ARCHITECTURAL

Question & Responses: Architectural Responses

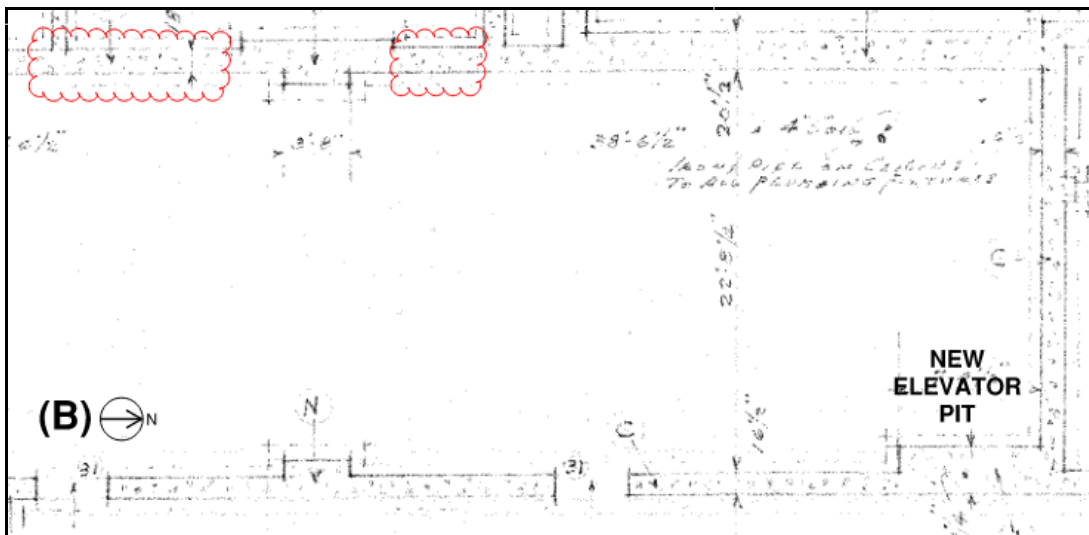
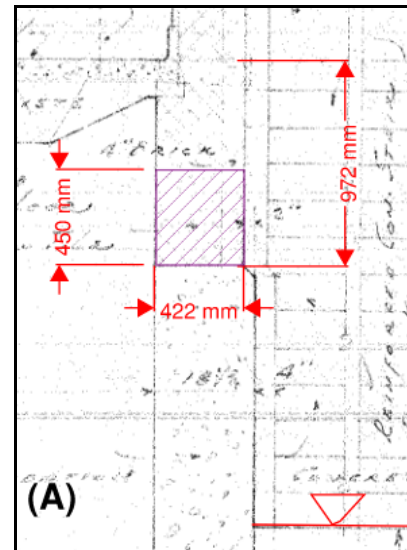
Q2 How can a 23-ft long steel beam be brought down to the crawl space? Is there a window that can be removed and re-installed?

ADD to project scope: to facilitate installation of new structural steel work, provide temporary opening cut into existing masonry wall to provide access into the crawl space area and in the location adjacent to the elevator. Refer to two drawing excerpts taken from the original building archive drawings: (A) partial wall section through west exterior wall at first floor, and (B) partial crawl space plan with available access points shown bubbled. The temporary opening is to be located centred between existing steel joists, max. height ranging up to 450mm and opening width not to exceed 300mm (max. width not requiring new structural lintel support). Reinstall matching face brick and concrete block infill, to restore wall. Also refer to related photo in response R3.

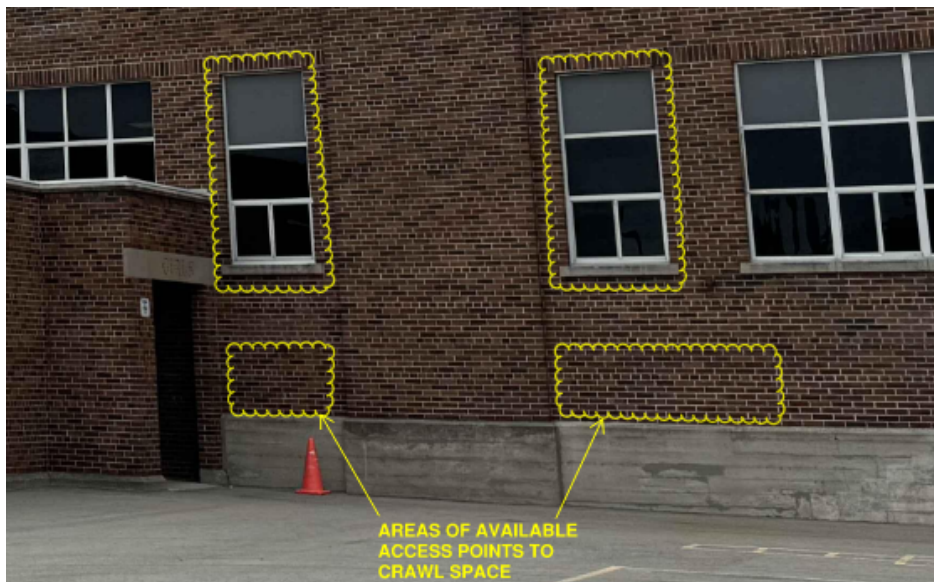
Q3 Can existing an window be removed and re-installed on ground floor as access for 15-ft steel beams?

ADD to project scope: to facilitate installation of new structural steel work, provide temporary removal and reinstallation of one existing exterior aluminum window located In Kindergarten 108. There are two identical existing west facing windows, located adjacent to the new elevator area, and either can be used for this temporary access. Refer to Ground Floor Key Plan on A1.00. Each aluminum window is approx. 1525W x 2450H in size and is comprised of insulated glazed units and one upper aluminum spandrel panel. Refer to west elevation photo below of these two optional windows shown bubbled (response R2 information also shown).
